Subject: Technical Specification Change Request No. 308 –
General Electric Stability Analysis Methodology

Oyster Creek Generating Station
Facility Operating License No. DPR-16
NRC Docket No. 50-219

Oyster Creek Technical Specification Change Request No. 308

Evaluation of Proposed Changes

Current Oyster Creek Technical Specification Scram and Rod Block Setpoints

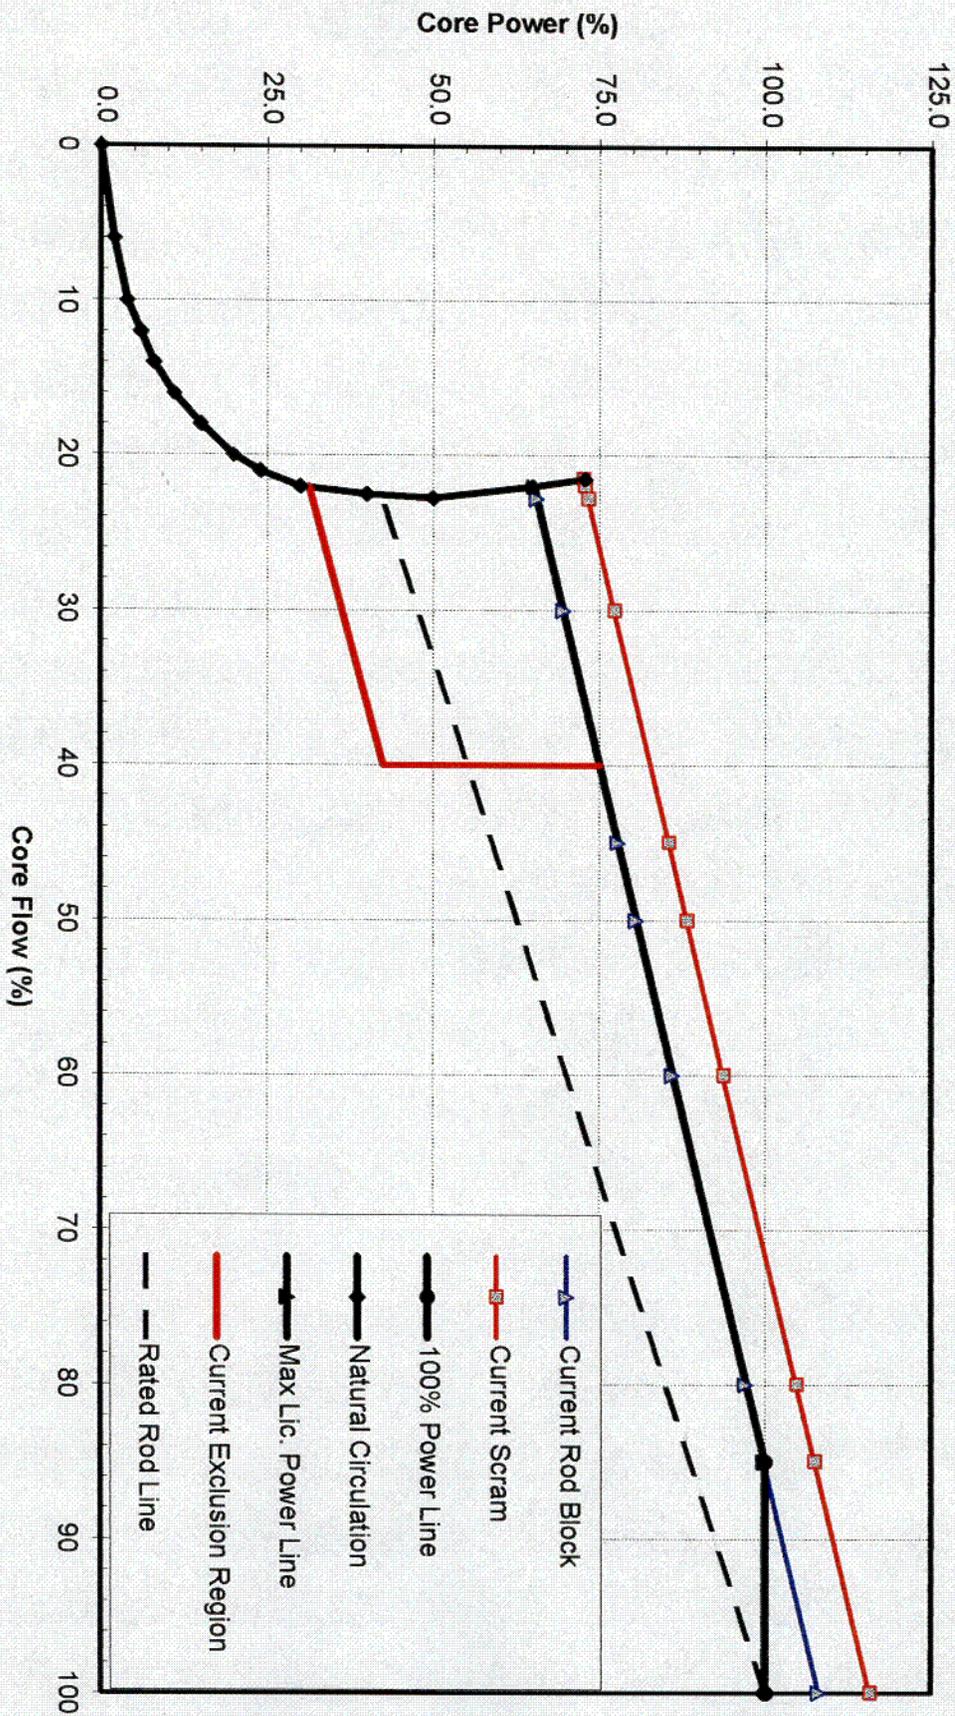
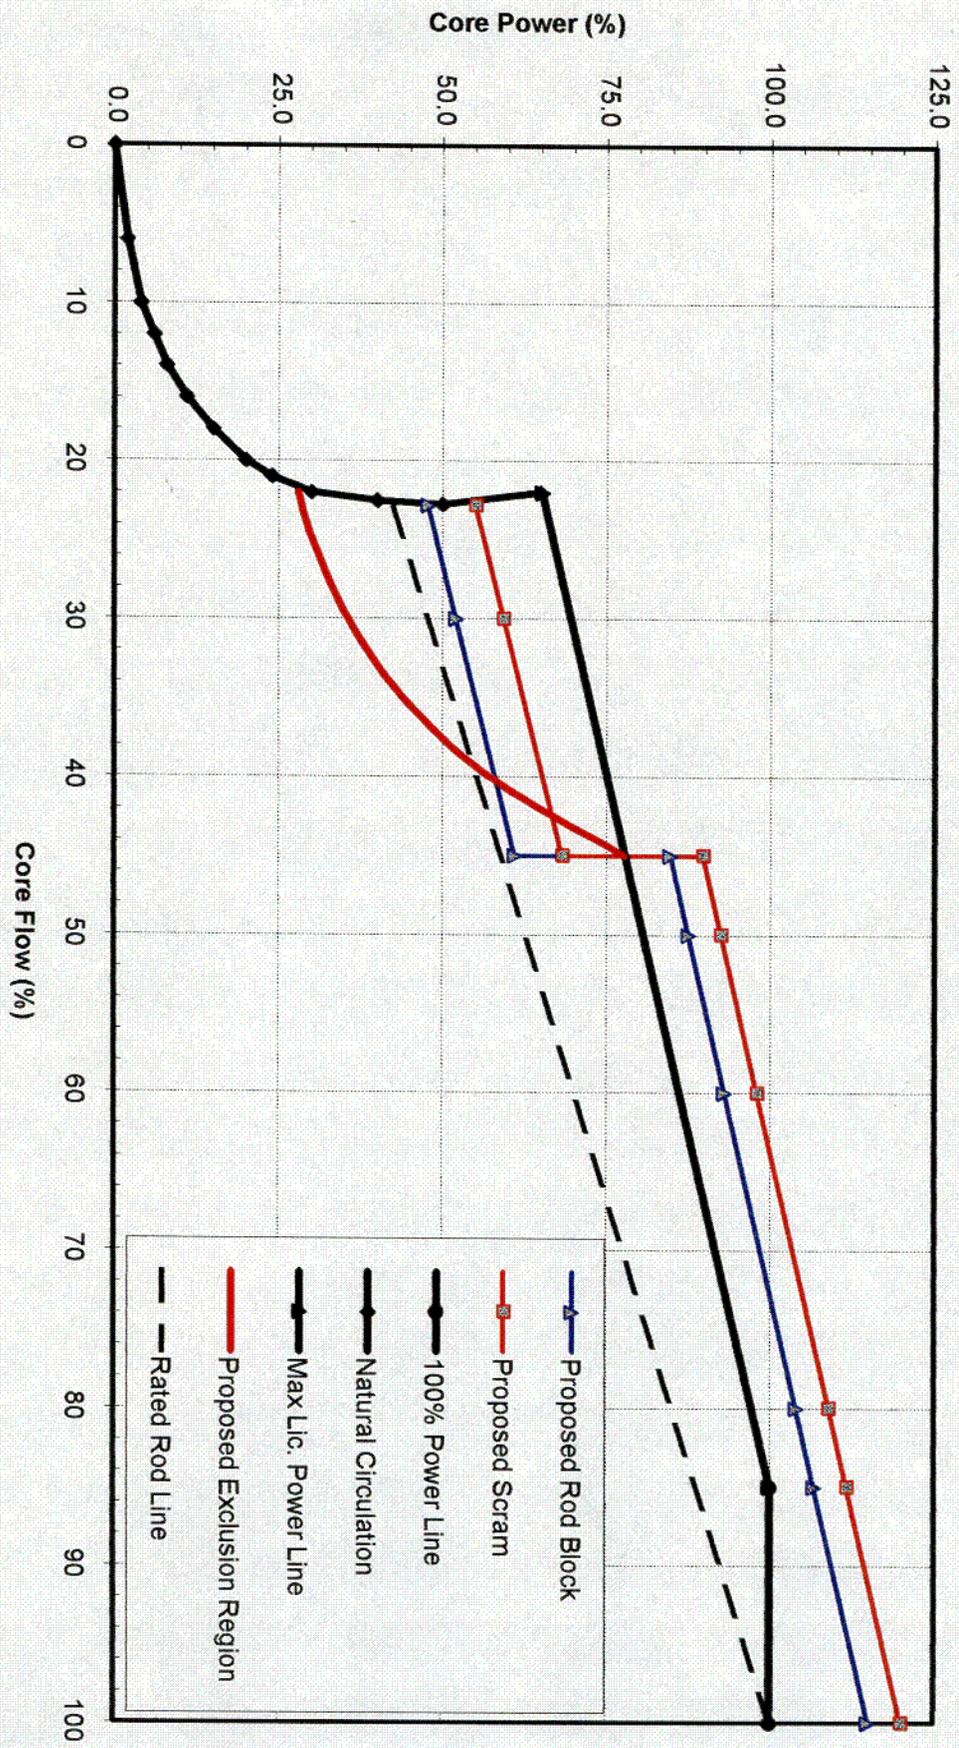
Attachment 1 provides a schematic showing the Extended Load Line Limit Analysis (ELLLA) region of the power/flow map as well as the current APRM flow biased neutron flux scram and rod block settings and stability restriction region. The current maximum values of the APRM flow biased neutron flux scram and rod block settings are 115.7% and 108%, respectively.

Attachment 2 provides a schematic showing the proposed APRM flow biased neutron flux scram and rod block settings and stability restriction region. The proposed maximum values of the APRM flow biased neutron flux scram and rod block settings are 120.0% and 115%, respectively (i.e., a 5% margin between the scram and rod block settings).

<u>Rod Block</u>	<u>Scram</u>
Current Setpoint:	$0.90E-6 * W(\text{lb/hr}) + 53.1$	$0.90E-6 * W(\text{lb/hr}) + 60.8$
Revised Setpoint:	$0.90E-6 * W(\text{lb/hr}) + 60.1$	$0.90E-6 * W(\text{lb/hr}) + 65.1$
